SITE INSTRUCTION

SI A15

PROJECT : Forestside
PROJECT # : 1331.15
DATE : Dec. 7, 2021

Title: Revisions to plans as itemized.

A-301c1

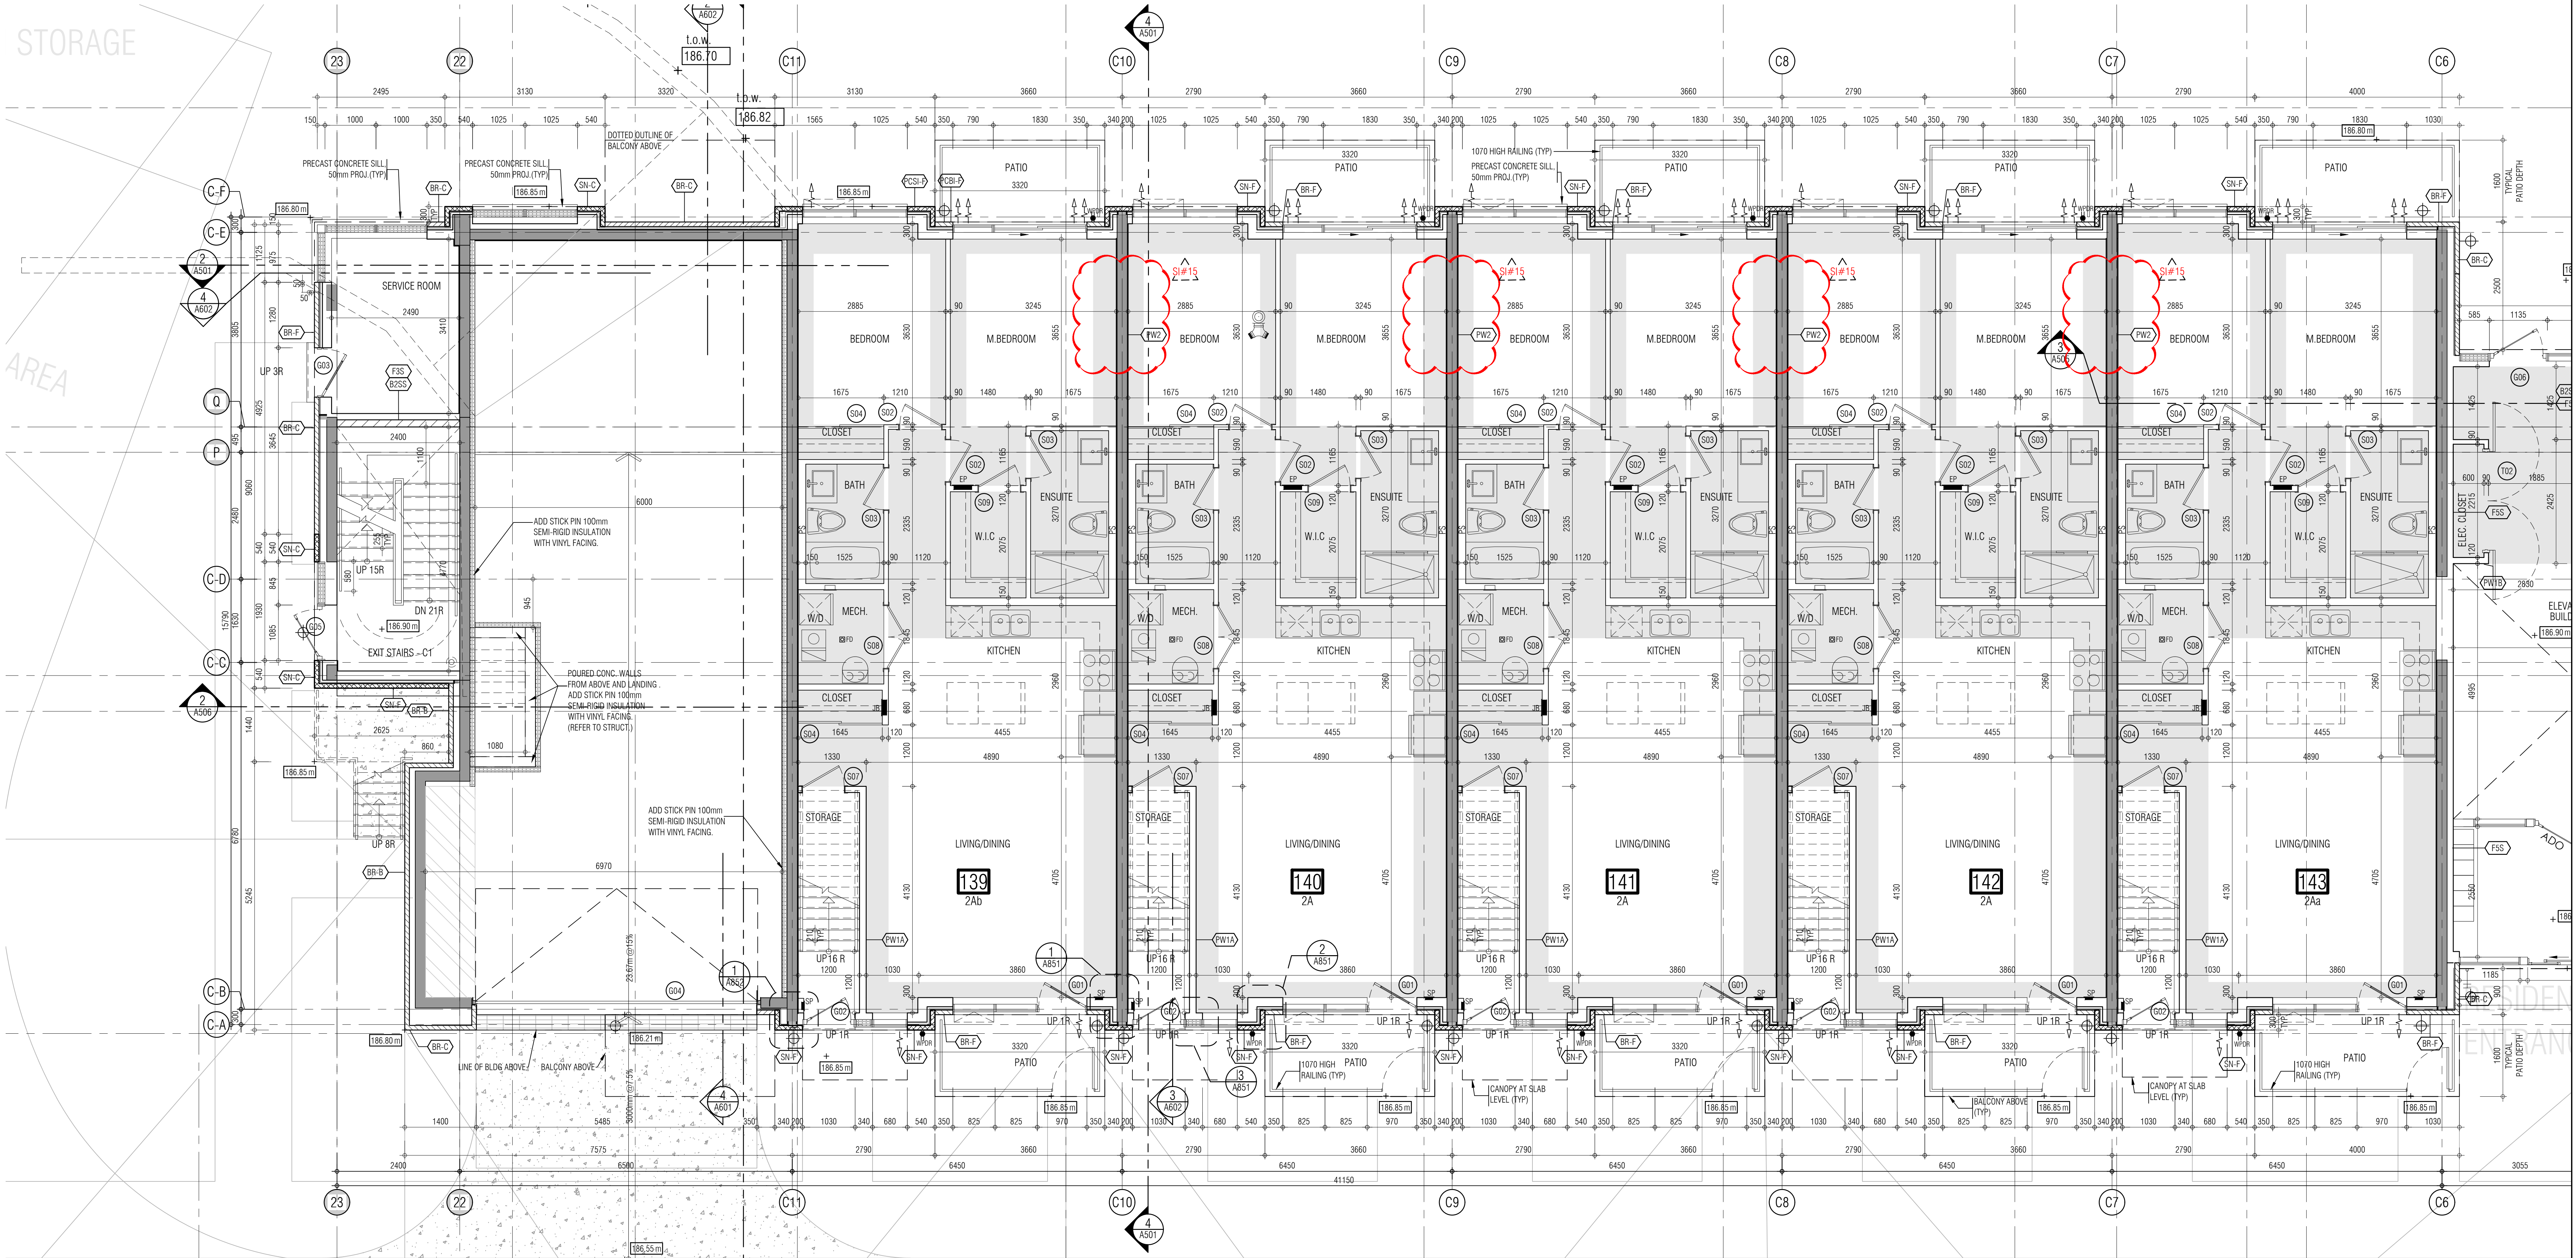
Reference:		Changes:
CS301-OS CS301a1, CS301b1 CS302, CS302a1, CS302a2, CS302b1, CS302b2, CS302d1, CS302d2	1st Floor Slab Edge	Fill in openings for construction access on concrete shear walls.
A301, A301c1, A301c2, A301d1, A301d2 A302, A302a1, A302a2, A302b1, A302b2, A302d1, A302d2	1 st Floor Plan Bldg. C & D 2 nd Floor Plan Bldg. A, B, & D	Fill in openings for construction access on concrete shear walls.

Reason: Revisions to plans of shear wall openings as per structural coordination.
